PLANNING AND ZONING COMMISSION STAFF REPORT

PROJECT: The Nest Pediatric Dentistry Building – Addition – Site Plan **PREPARED BY:** Bill Mettee – Planner

REPORT DATE: January 5, 2024

AREA MAP

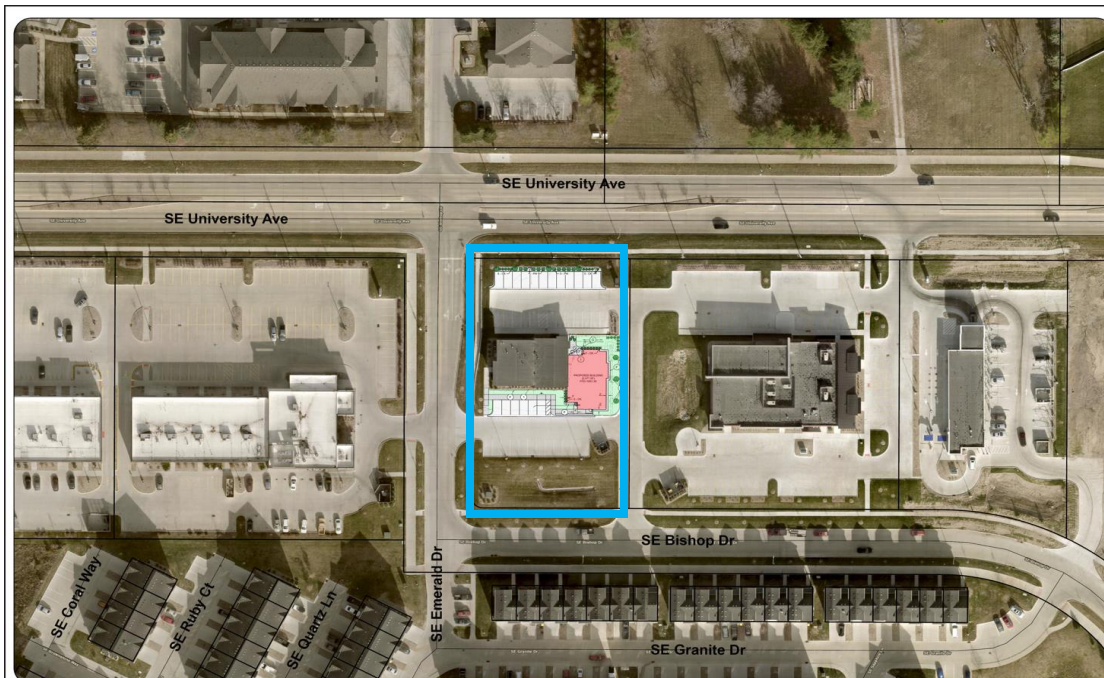
ABOVE: Aerial of Property identifying the proposed plat (outlined in **BLUE**).
